DESIGN REVIEW BOARD

September 9, 2025
7:00 PM

FINAL AGENDA

AGENDA ITEM REPORT
September 9, 2025

REVISED SITE PLAN

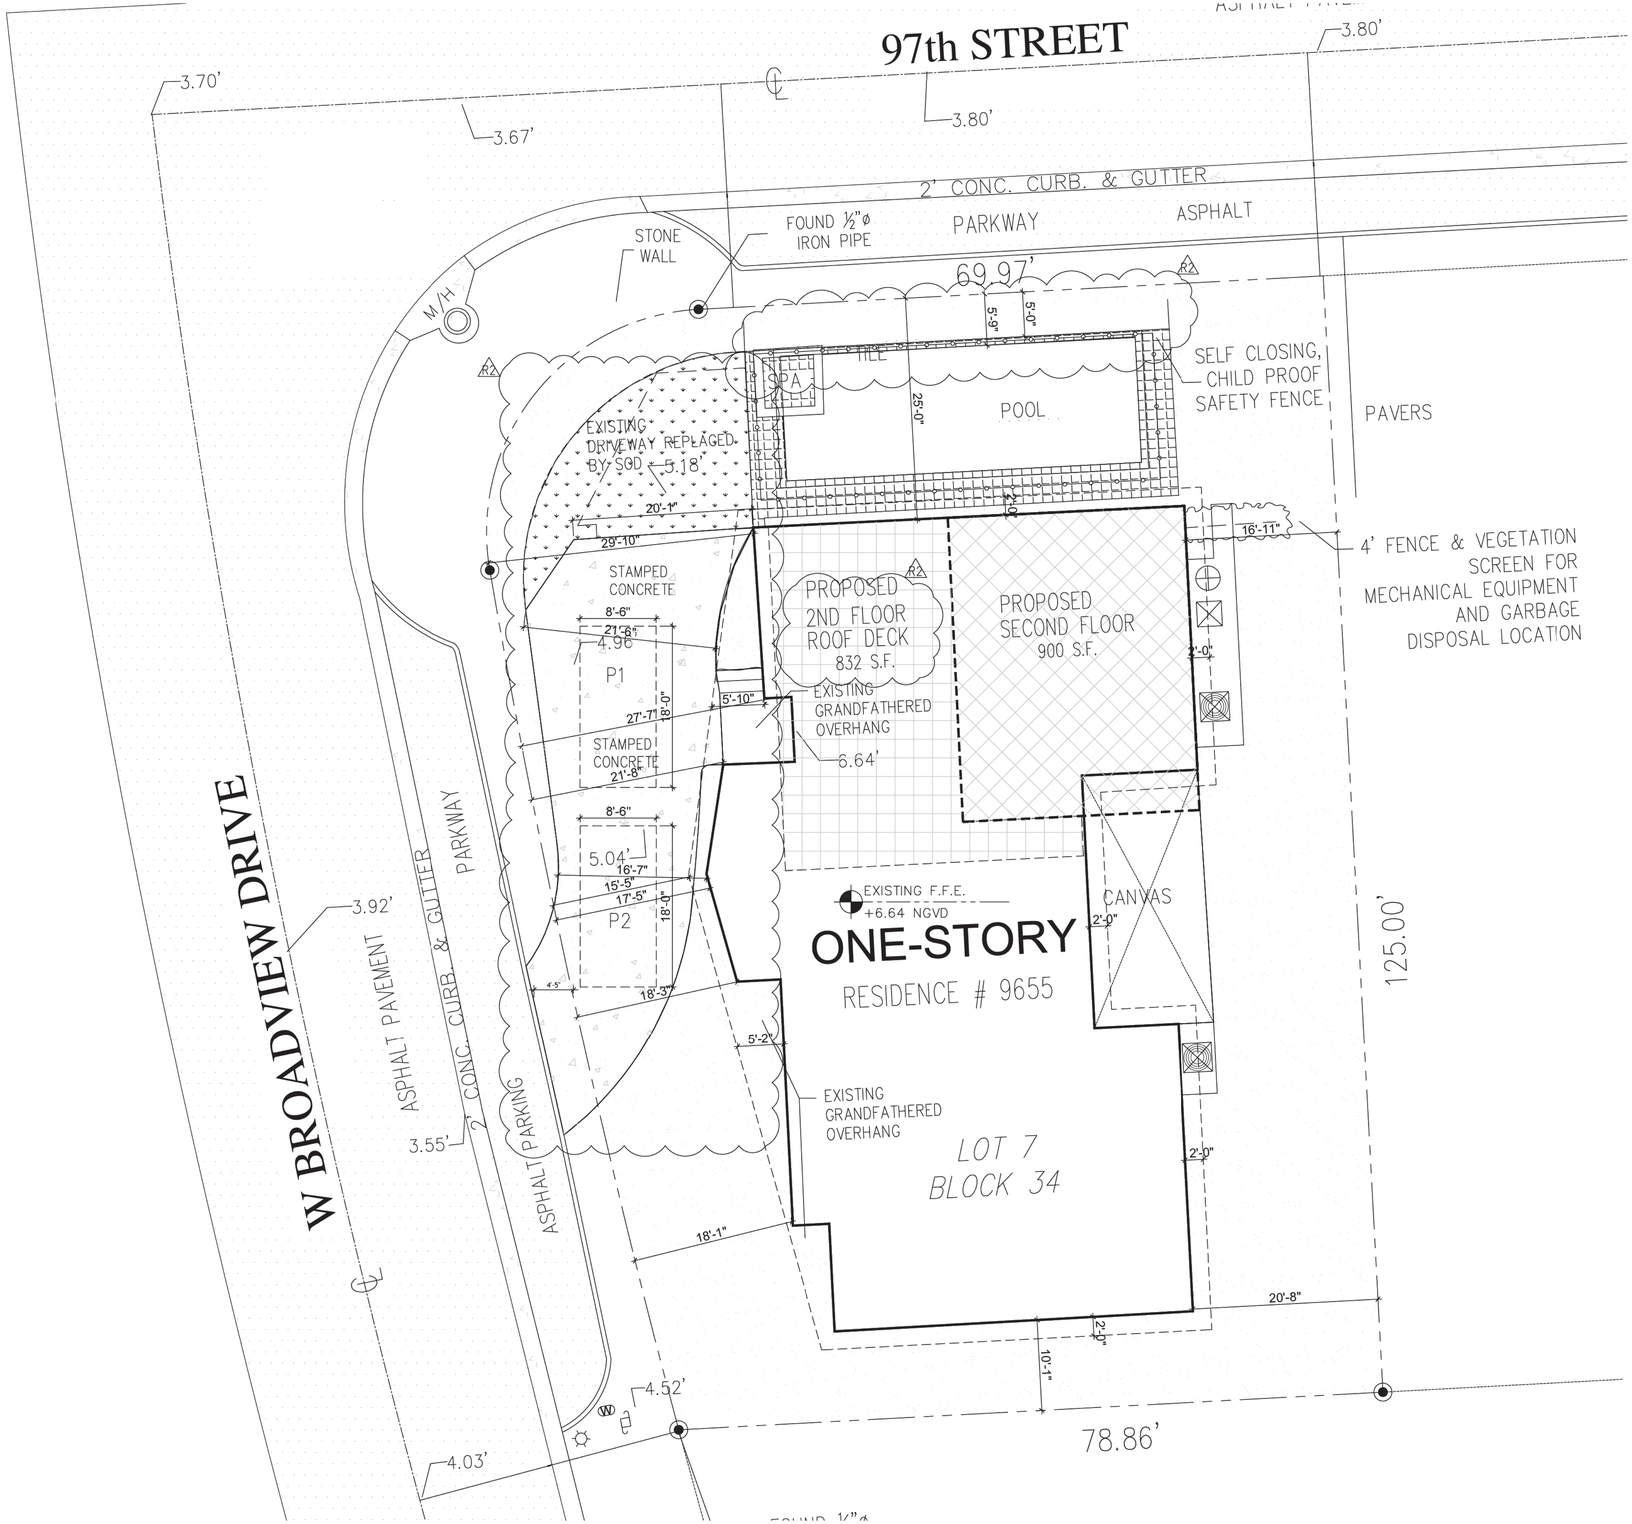
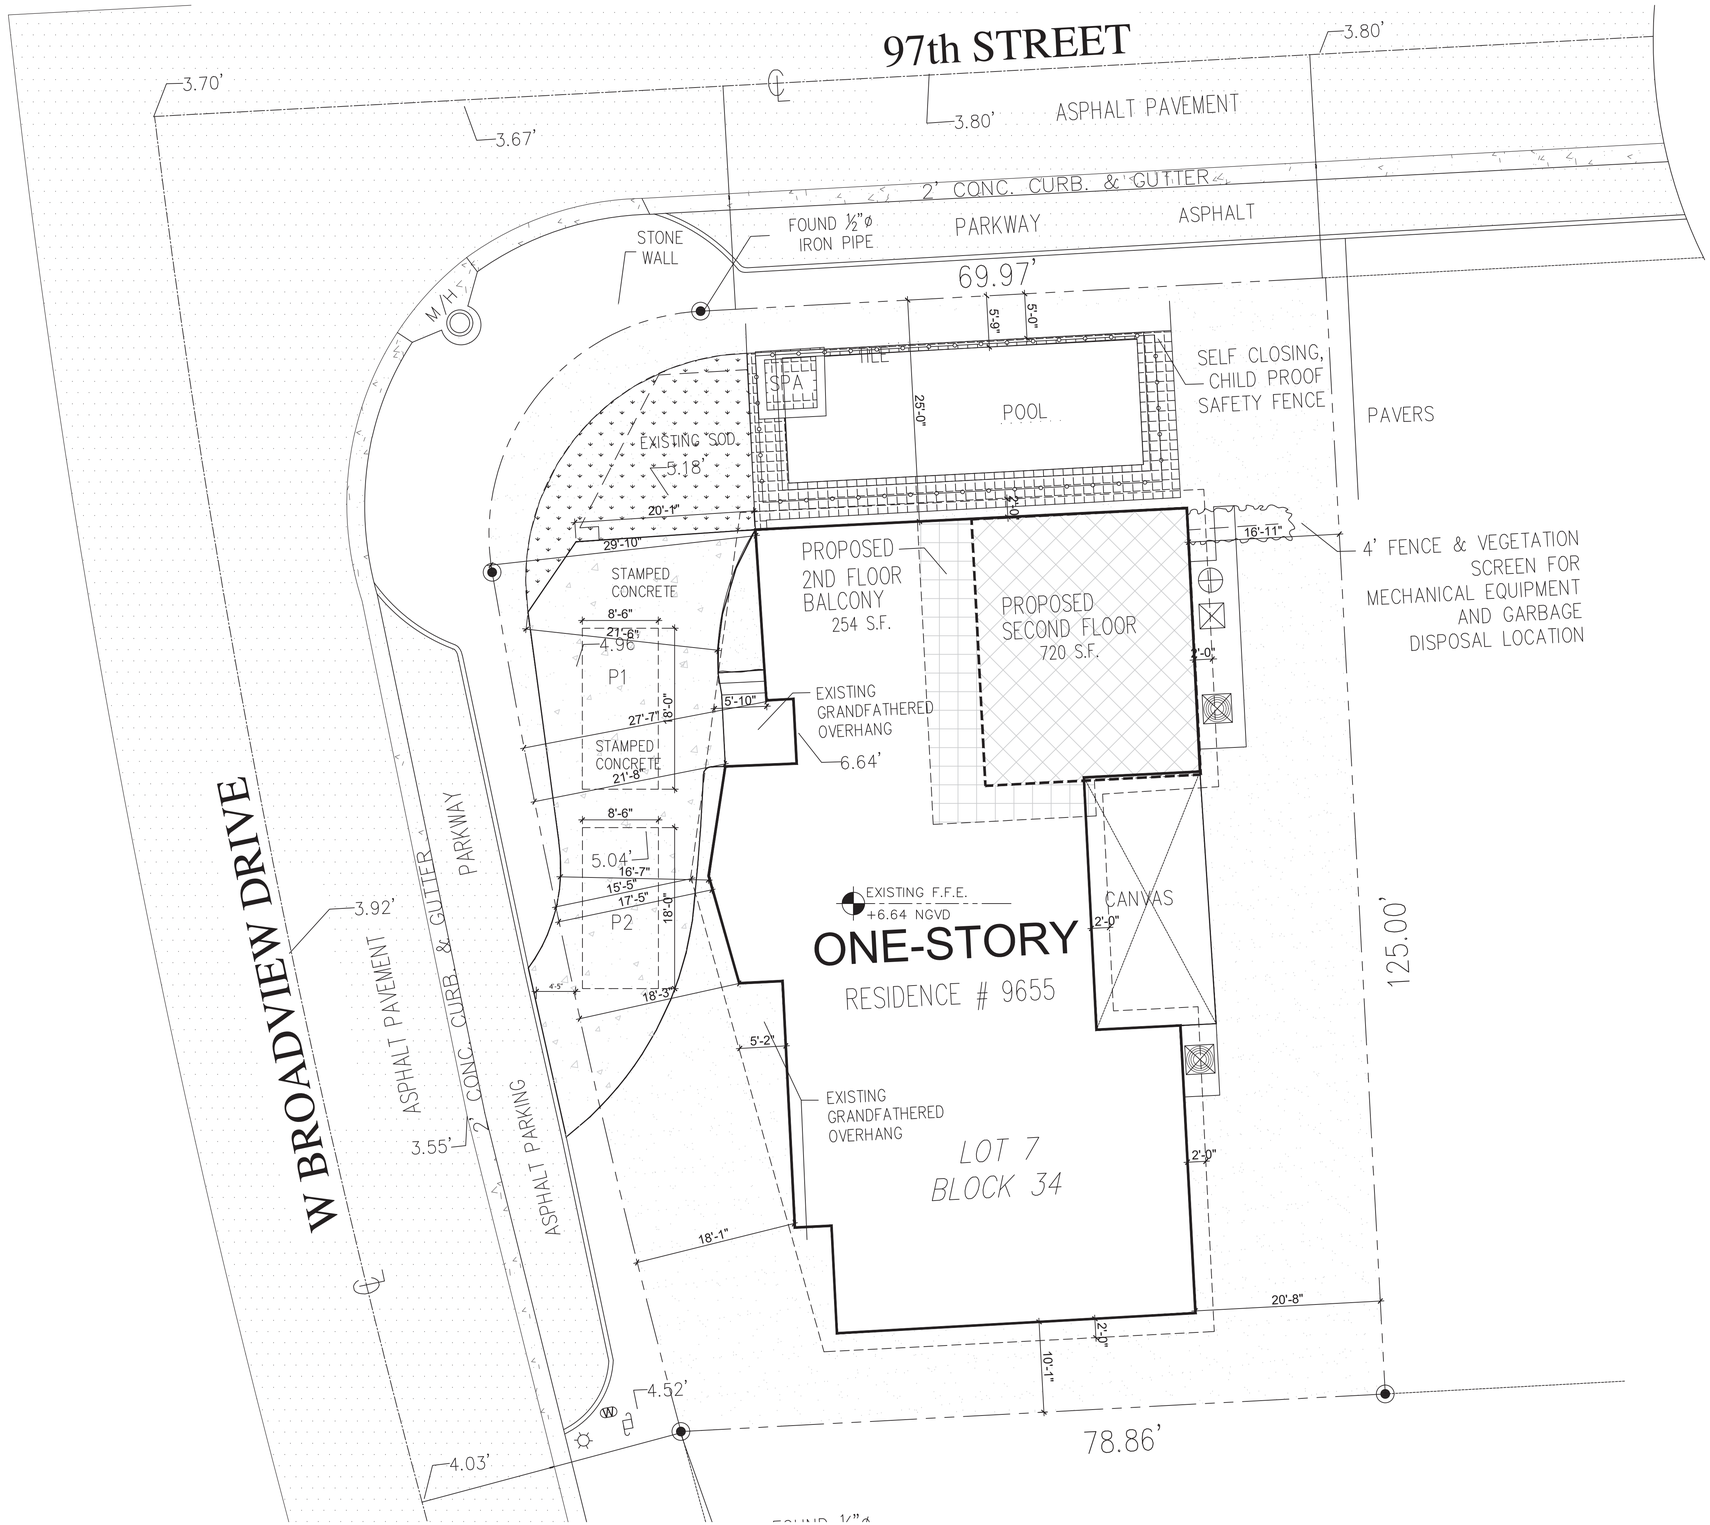
2) On Sheet A1.0 Site Plan the 2nd Floor Plan notes the proposed rooftop deck next to the addition as a "balcony". Clearly this is not a balcony which is attached to the exterior of a wall at a door / window opening and extends into open space. This was brought up during the DRB review and the plans were corrected to use the right nomenclature. Not sure why this sheet that was corrected before now has the incorrect term again. Revise the plan set.

3) On Sheet A1.0 Site Plan the 2nd Floor Plan addition was reduced in size significantly from 900 sq. ft. to only 720 sq. ft. The project must be built exactly as the plans were approved, unless the DRB approves a revision.

4) On Sheet A1.0 Site Plan the 2nd Floor Plan roof deck areas was reduced in size significantly from 832 sq. ft. to only 254 sq. ft. The project must be built exactly as the plans were approved, unless the DRB approves a revision.

(REVISED SITE PLAN)

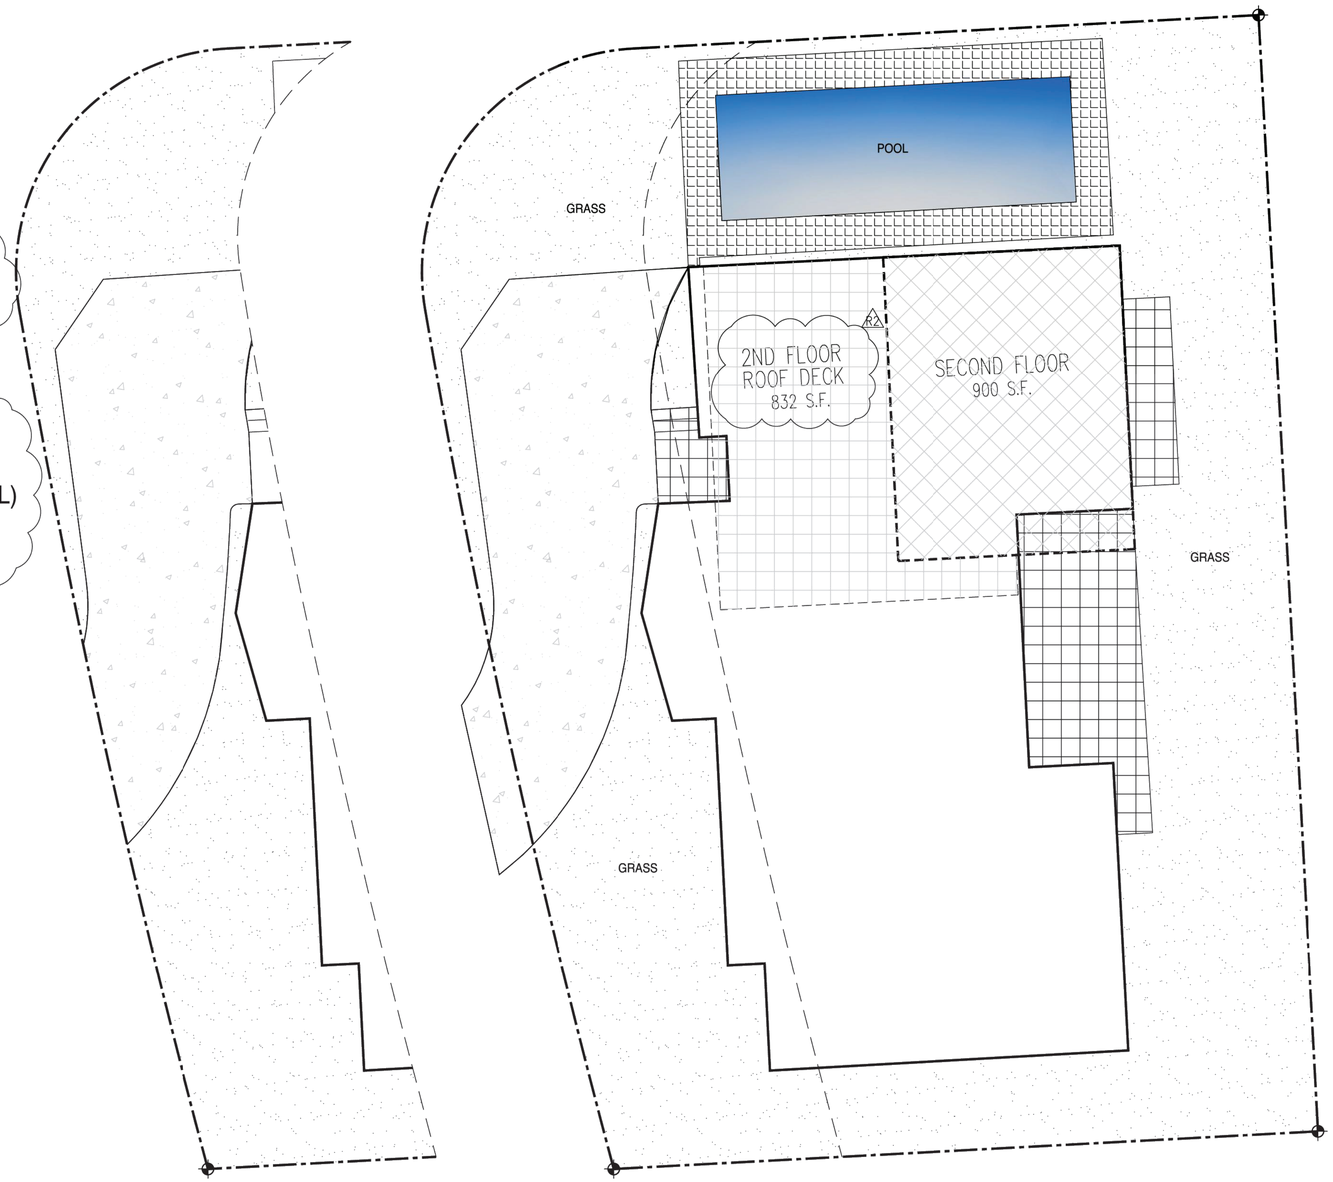
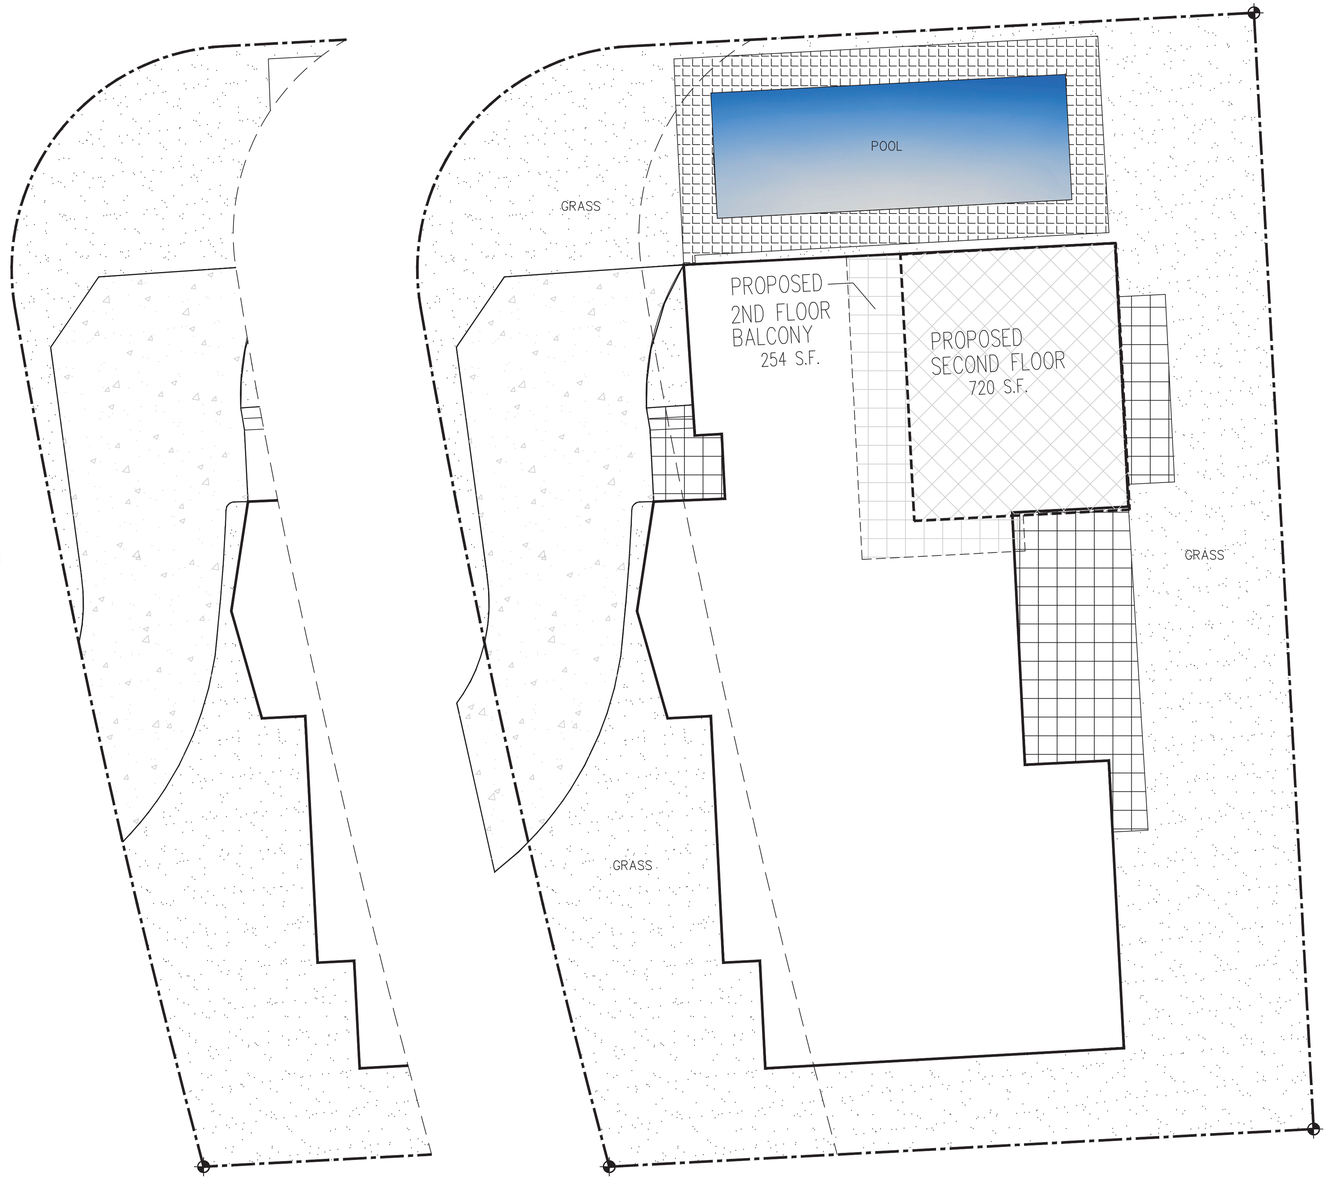
6) On Sheet A1.2 the BP plan drawings show the same significantly modified 2nd Floor addition and roof deck square footages. This does not match the approved DRB plans. The project must be built exactly as the plans were approved, unless the DRB approves a revision.

REVISED FLOOR PLAN

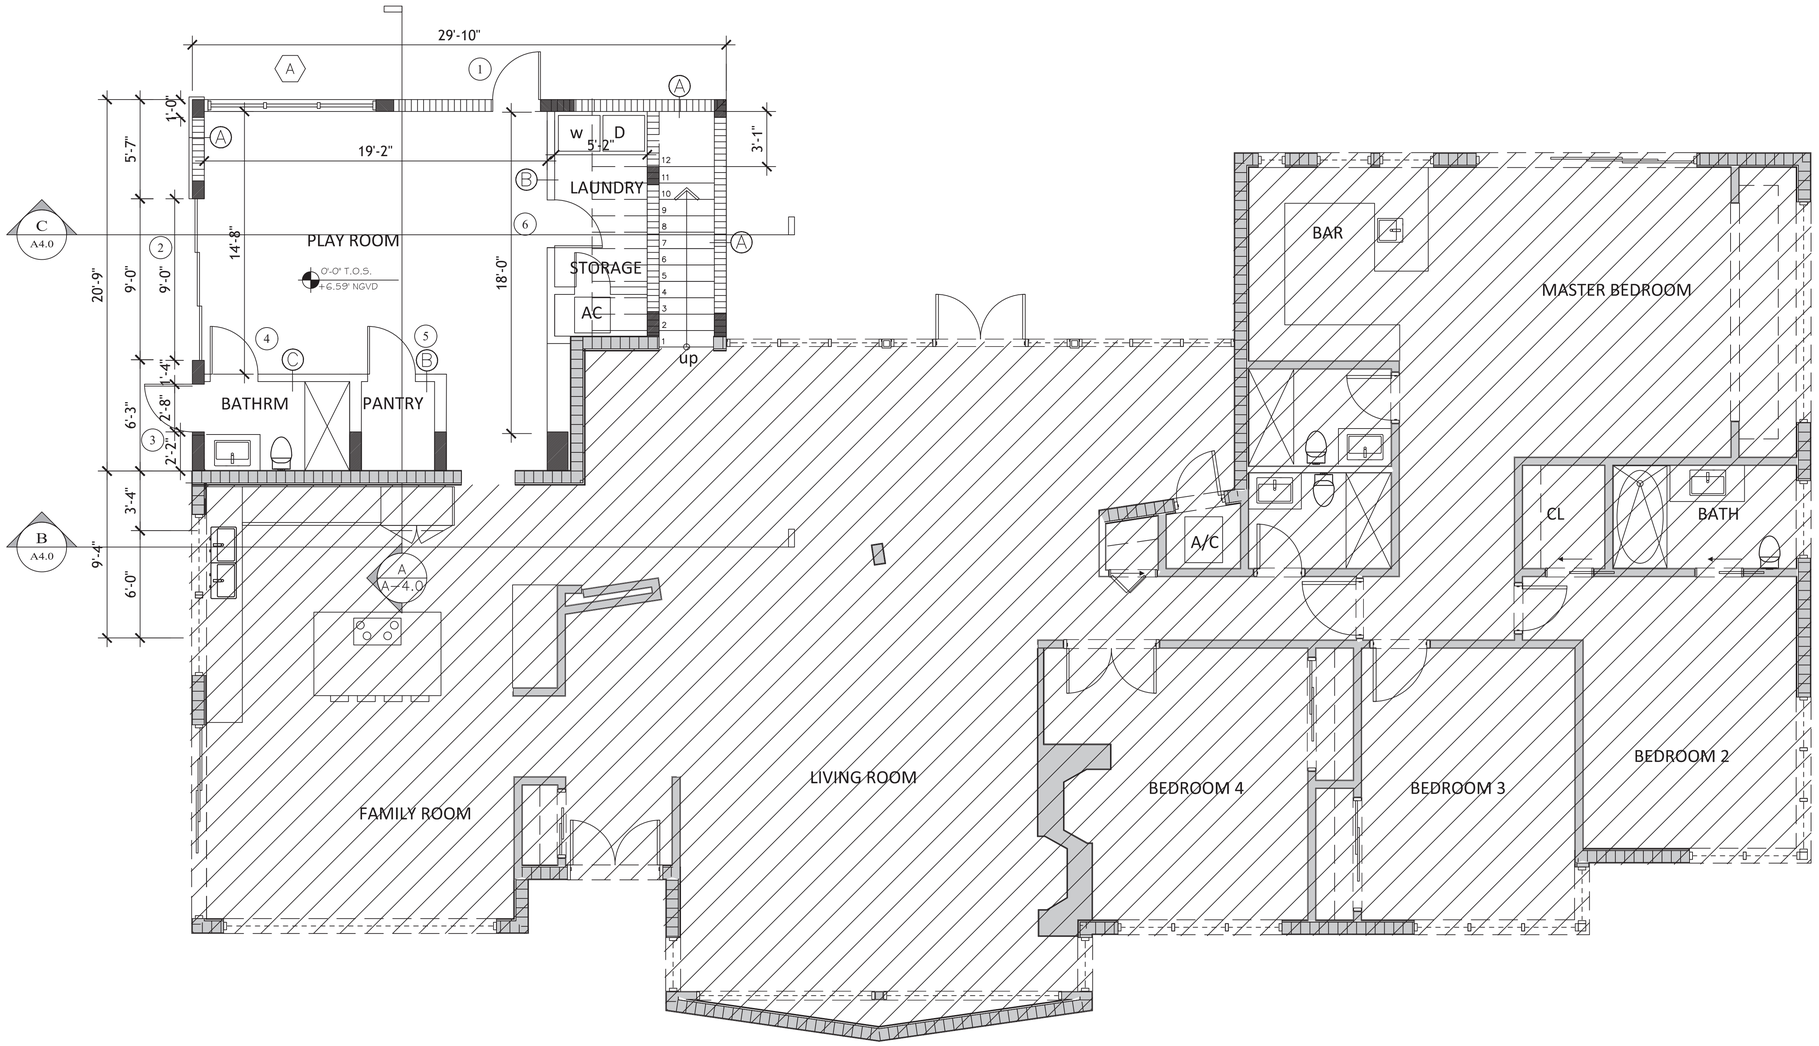
7) On Sheet A2.1 the BP plan drawings show the same significantly modified 2nd Floor addition and roof deck square footages. Change the term "balcony" to "roof deck" to correctly identify that feature. Again, this does not match the approved DRB plans. The project must be built exactly as the plans were approved, unless the DRB approves a revision.
